CASE NO. FP-2022-0026

ORDER OF CONDITIONAL
APPROVAL OF FINAL PLAT

SUBJECT: FP-2022-0026
Gander Creek South Subdivision No. 3

Final plat consisting of 75 single family residential building lots and 10 common lots on 13.77 acres of land in the R-8 zoning district for Gander Creek South No. 3.

B. Final Plat (not dated)

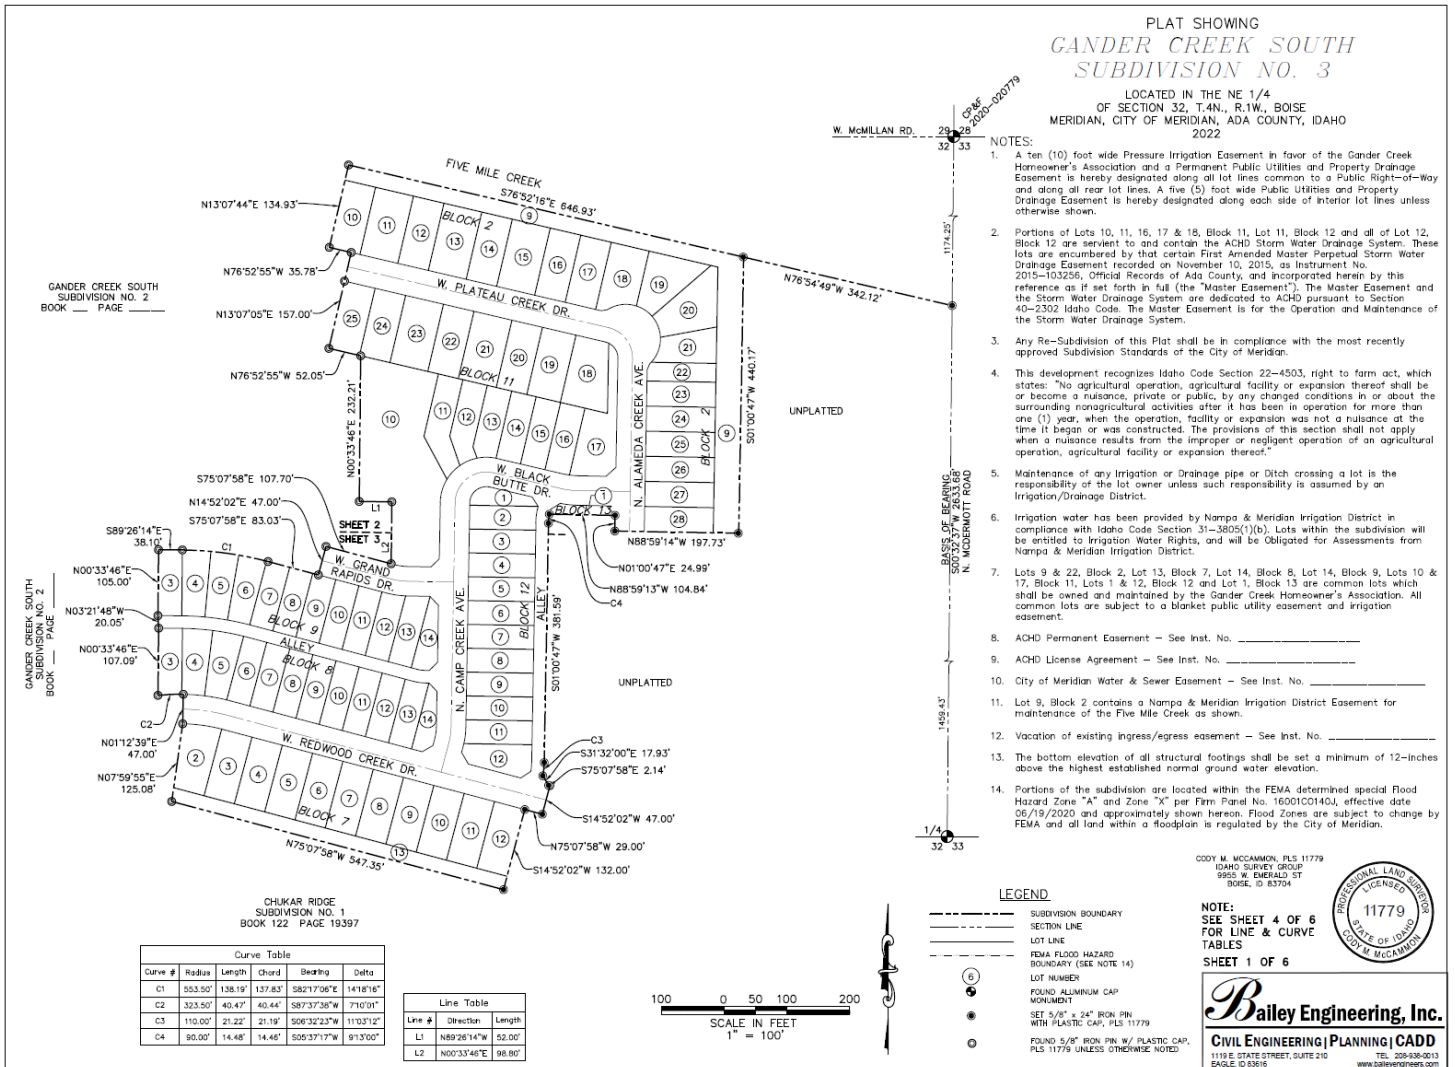
3. Prior to submittal for the City Engineer's signature, have the Certificate of Owners and the accompanying acknowledgement signed and notarized.
4. The final plat prepared by Bailey Engineering, Inc. by Cody McCammon, included in Section V.B shall be revised as follows:

- a. Note #8: Include the recorded Instrument Number for the ACHD Permanent Easement.
 - b. Note #9: Include the recorded Instrument Number for the ACHD License Agreement.

- c. Note #10: Include the recorded Instrument Number for the City of Meridian Water & Sewer Easement.
 - d. Note #12: Include the recorded Instrument Number for the vacation of the existing ingress/egress easement.

- e. Revise Lot 12, Block 11 to comply with the minimum 30-foot wide street frontage requirement in UDC 11-2A-3B.1, measured as a chord measurement.
 - f. All buildable lots shall have a minimum 40-foot wide street frontage, except for properties with street frontage on cul-de-sacs or at approximately a 90-degree angle, which shall be a minimum of 30 feet, measured as a chord measurement; correct all lots that don't conform.

JENSEN BELTS ASSOCIATES
 Site Planning / Landscape Architecture
 1000 Sprad Lane, Ste. 100 Dallas, TX 75208
 Tel. 972.341.1100

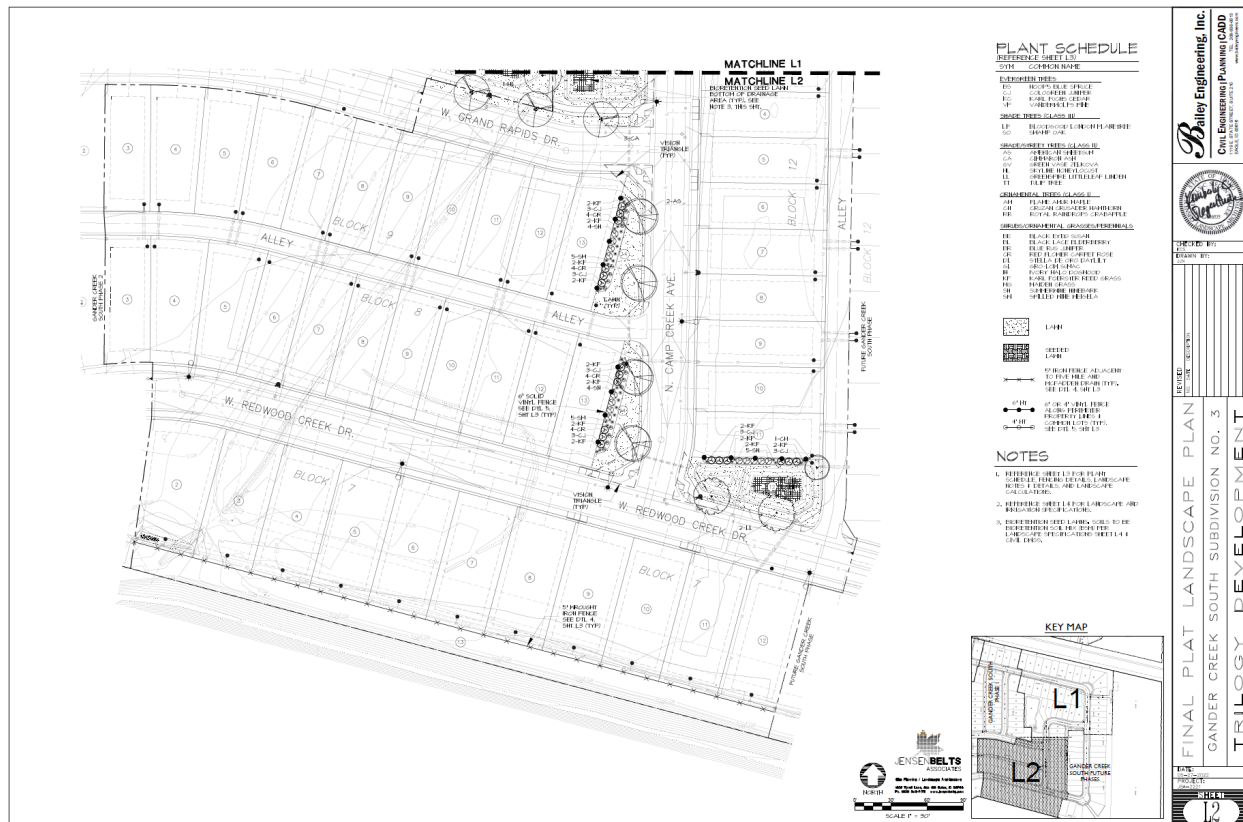
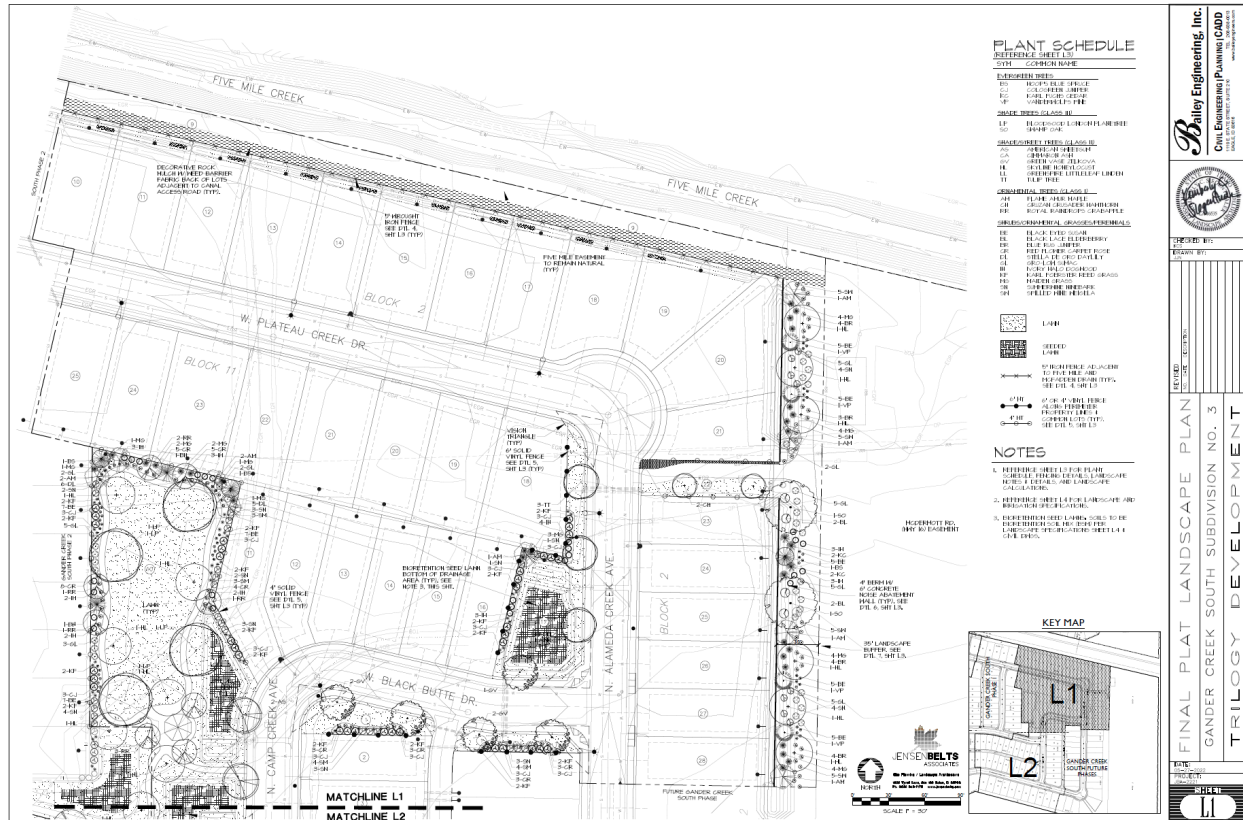
5. The landscape plan prepared by Jensen Belts Associates, dated 05/27/2022, included in Section V.C, shall be revised as follows:
 - a. In the Landscape Calculations table, include the required vs. provided number of trees along pathways that demonstrate compliance with UDC [*11-3B-12C.2*](#).

- b. Depict a 6-foot tall berm with a 6-foot tall wall on top of the berm as noise abatement along the east boundary of the site adjacent to future SH-16 as required by City Council at the hearing on May 28, 2019 in accord with set forth in UDC 11-3H-4D for residential uses adjoining state highways; also modify the detail for the berm. *The plan currently depicts a 4-foot tall berm with a 6-foot tall concrete wall.*

- c. A detail shall be included that depicts the centerline (or estimated centerline) of the future SH-16 in relation to the top of the berm/wall verifying it's a minimum of 12-feet higher than the elevation at the centerline of the state highway as required by UDC 11-3H-4D.2. The Director may approve alternative compliance as set forth in UDC 11-5B-5 where the Applicant has a substitute noise abatement proposal in accord with ITD standards and prepared by a qualified sound engineer as set forth in UDC 11-3H-4D.4.

- d. The 6-foot tall closed vision fence along the east boundary of the subdivision adjacent to N. McDermott Rd./future SH-16 shall be removed and either a use easement recorded across the

back side of the berm along McDermott/SH-16 benefitting adjacent building lots with allowance for side yard fences to be constructed to the wall on top of the berm; or, an open vision, 4-foot tall closed vision, or 4-foot tall closed vision with 2 foot open vision fencing on top could be constructed for visibility of the common area between the fence and wall on top of the berm.
